March 28, 2013

Re: Dufferin Wind Power Inc. - Application for Leave to Construct (EB-2012-0365) - Second Amendment to Application and Pre-filed Evidence

## **REA Changes Report**

Renewable Energy Approval
Changes Report

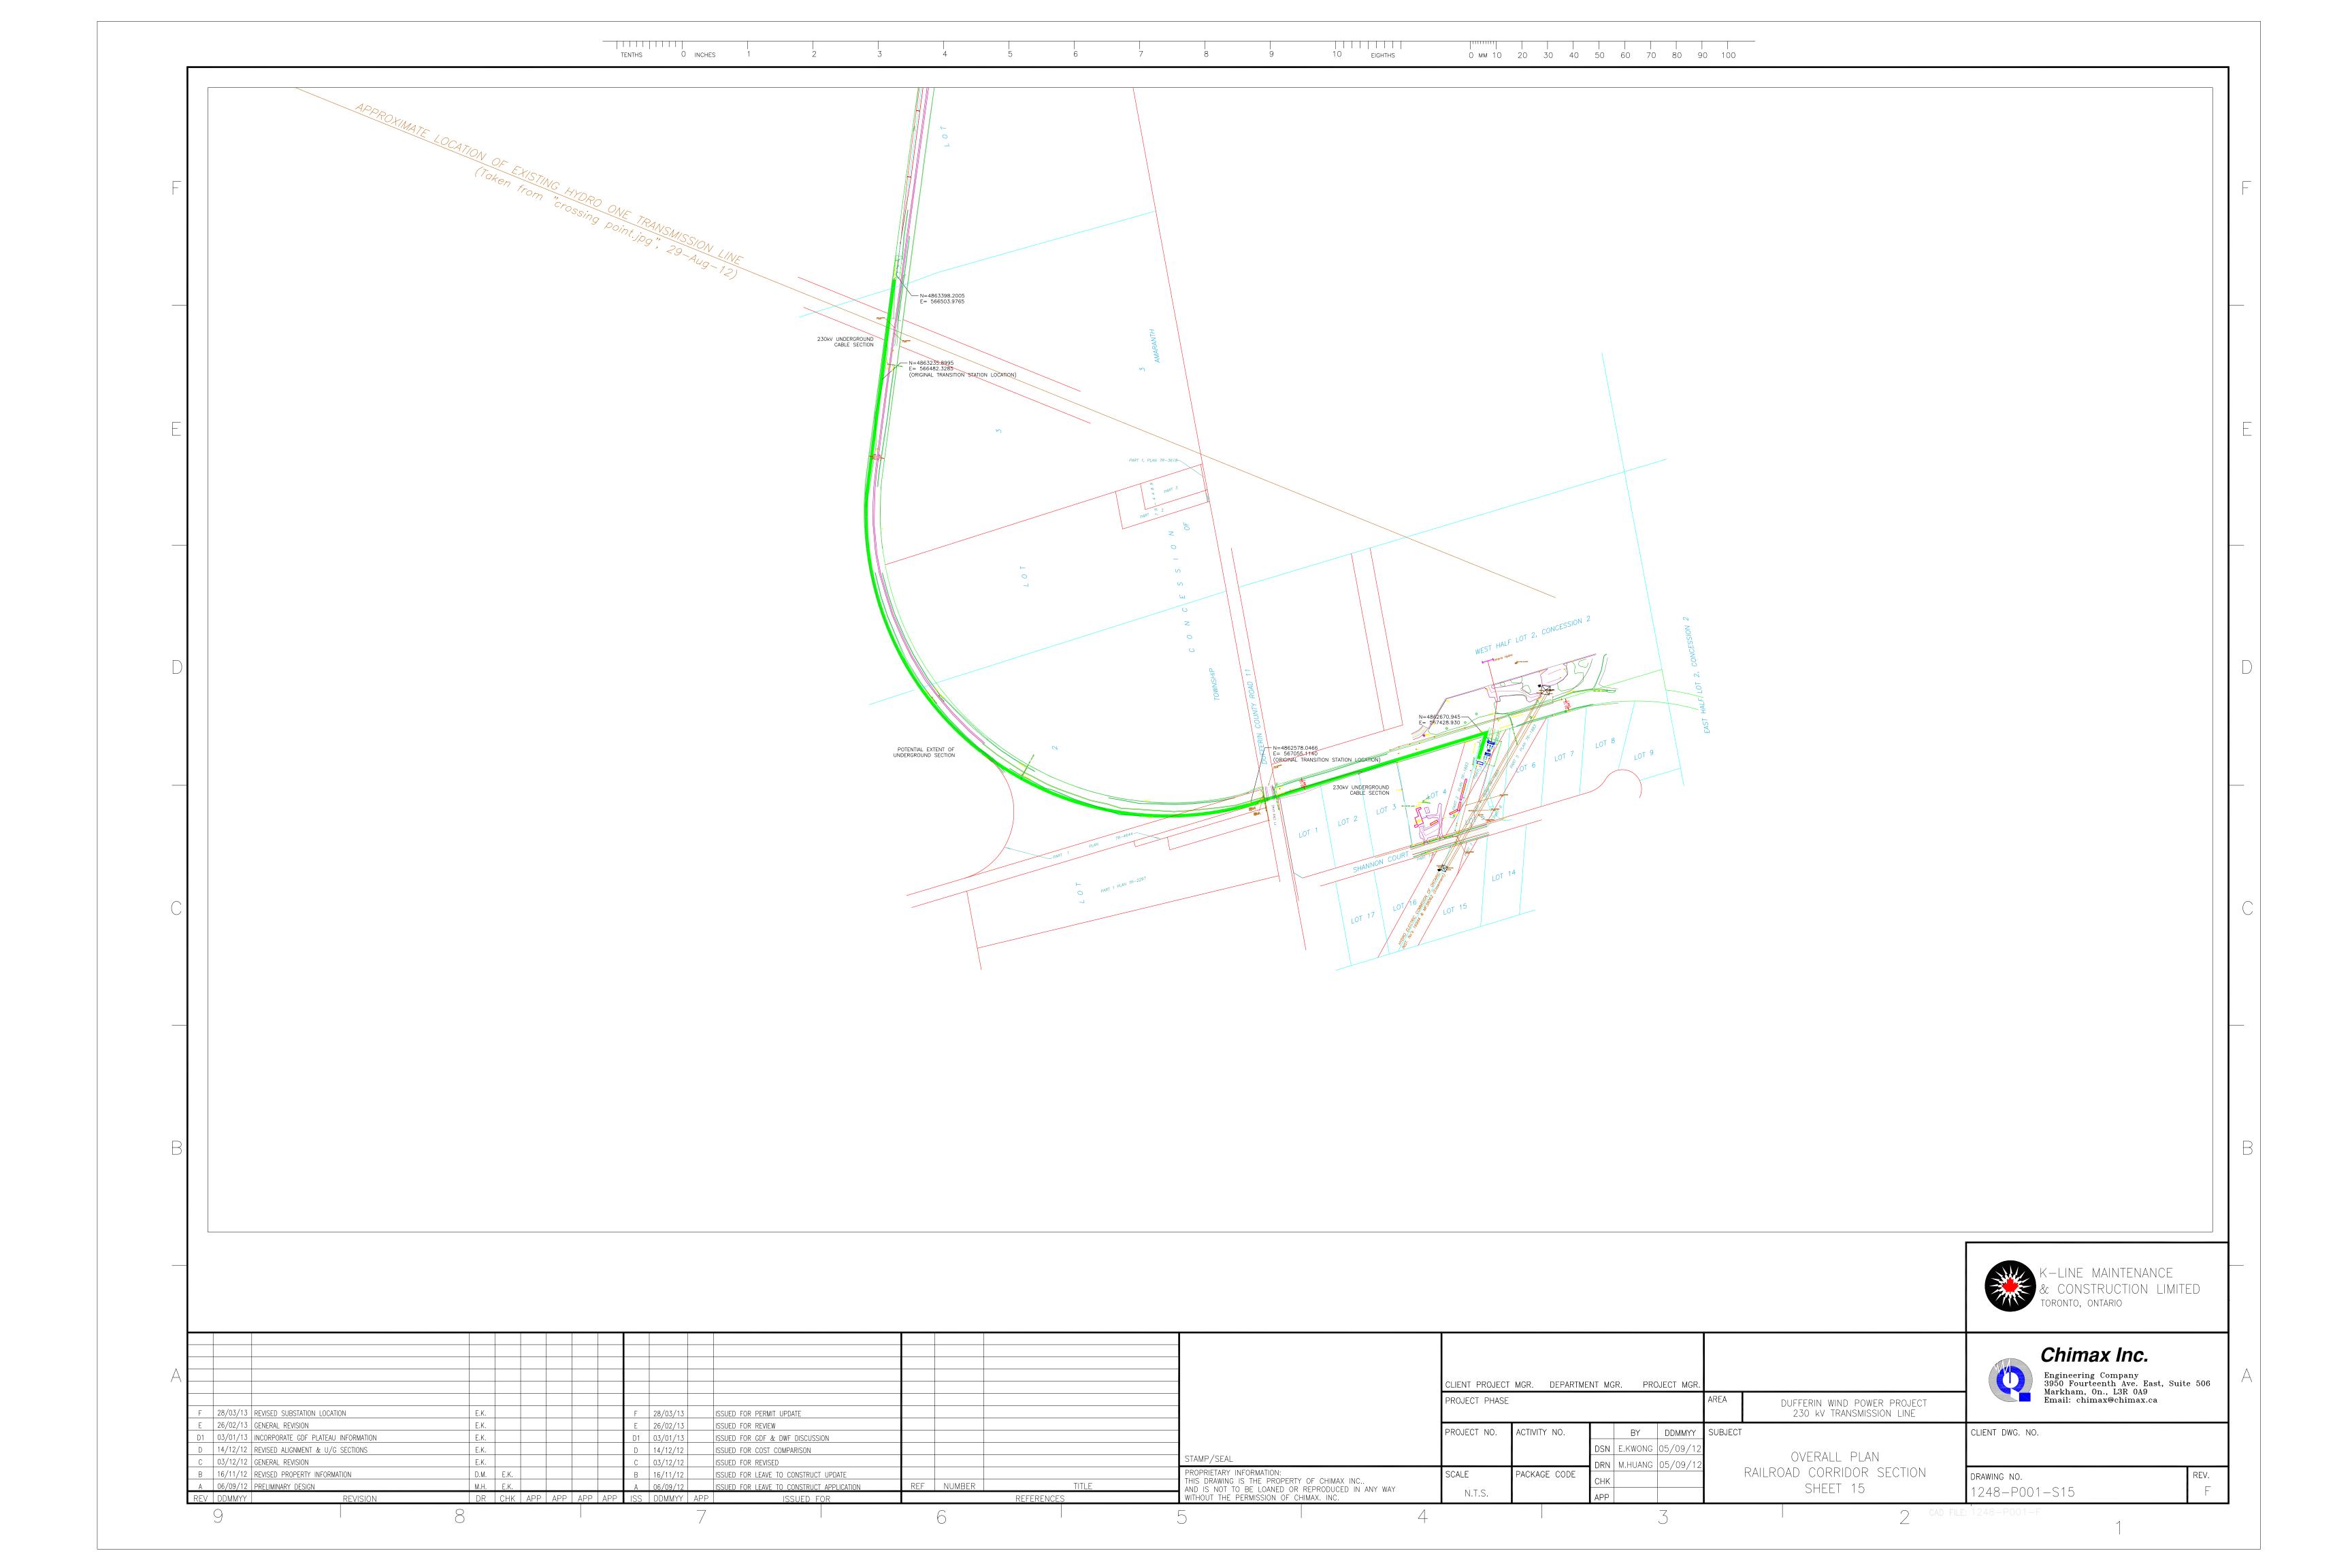
Map 5(a) in Exhibit B, Tab 2, Schedule 4 of the Application, which is marked as Drawing No. 1248-P001-S01 - Revision A, currently shows that at the point where the transmission line route reaches the west side of 4th Line it will transition from overhead to underground. The line would then cross 4th Line underground and continue running to the west underground for approximately 250 m, at which point it would transition from underground back to overhead and continue in a south-westerly direction. The thick green line on Map 5(a) depicts the approximate length of this underground segment.

DWPI amends this portion of the transmission line route. At the point where the transmission line route reaches the west side of 4th Line, rather than transitioning from overhead to underground the line would remain overhead and run south along the east side of 4th Line within the municipal road right-of-way for a length of approximately 110 m. The line would then cross over 4th Line and continue to the west until the point where it meets the transmission line route as shown in the current version of Map 5(a). An amended set of maps, including in particular a revised Map 5(a), together with blacklined pages showing corresponding changes to the pre-filed evidence and certain interrogatory responses, is provided in Appendix 'B'.

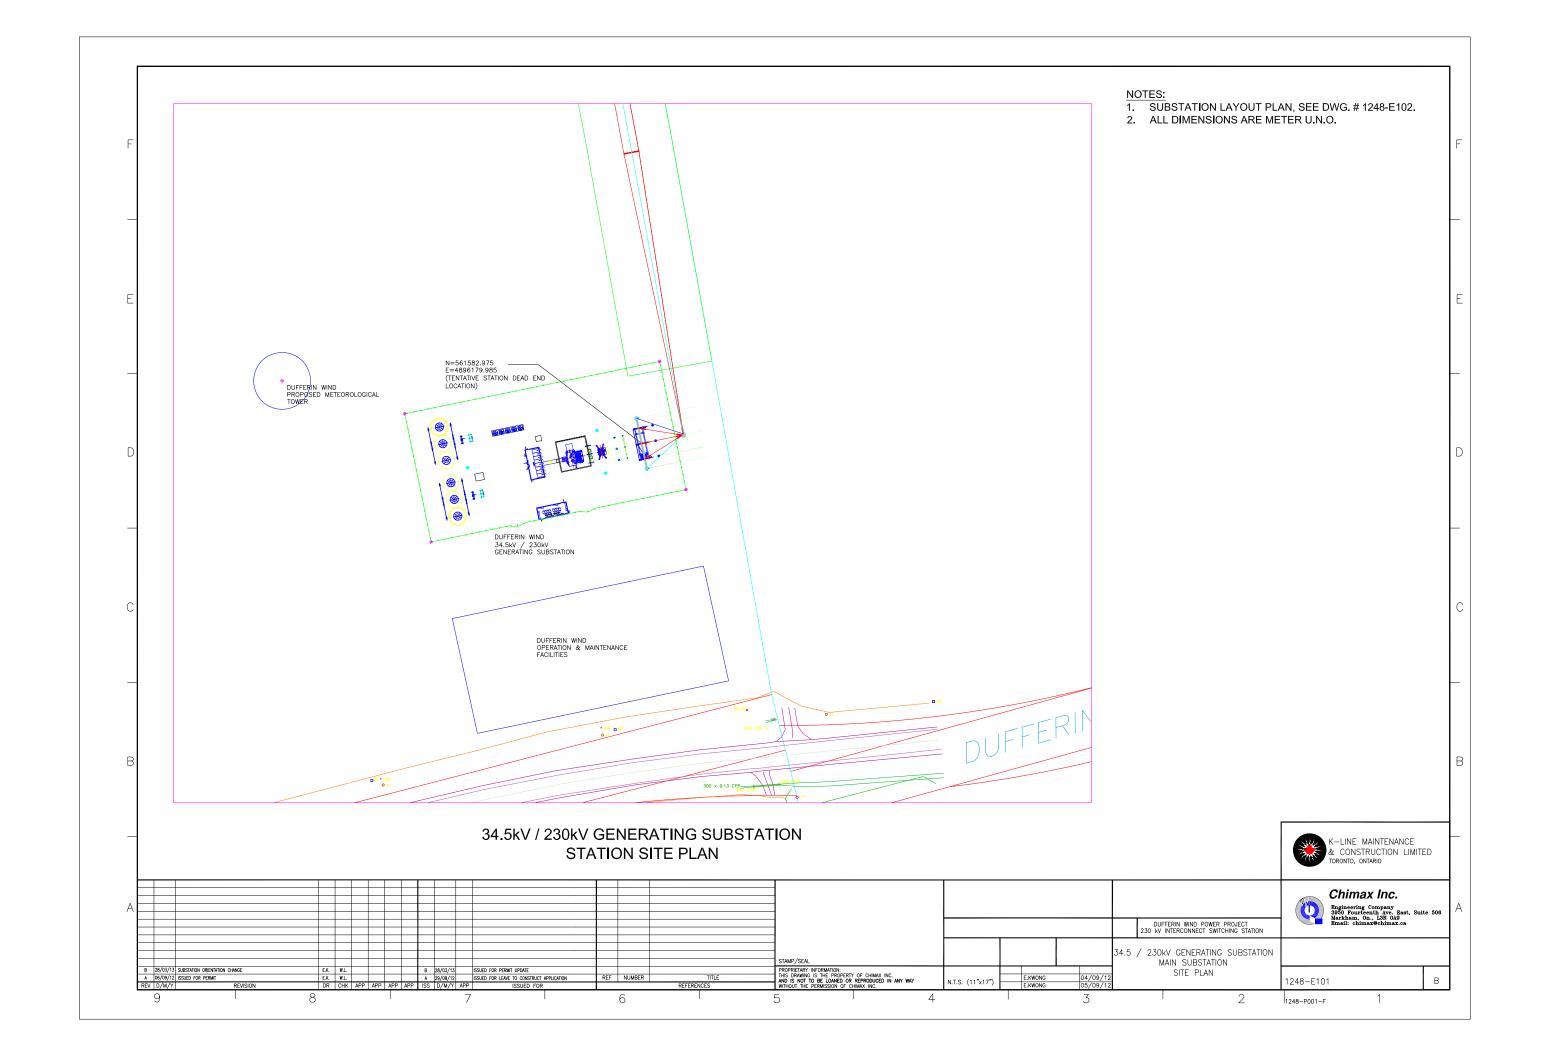
DWPI also amends the orientation of the project substation. Although the location of the substation will not change, rather than being situated with a north-south orientation, it will instead be situated with an east-west orientation. This change results from discussions with the affected landowner and is in response to the landowner's desire to maximize the area available for productive agriculture. Not only does this allow for a more compact layout, but it also allows for the transmission line running up the east side of the property to be positioned closer to the property boundary so as to minimize the impact on the remainder of the property. The Applicant has determined that no changes are required for purposes of the REA application to reflect this reorientation as the REA already contemplates an area that incorporates the revised station footprint. The revised orientation is shown in the amended Exhibit B, Tab 2, Schedule 4, Figure 5(a) and in the amended Exhibit B, Tab 2, Schedule 5, Figure 2(a), both of which are included in Appendix 'B' hereto.
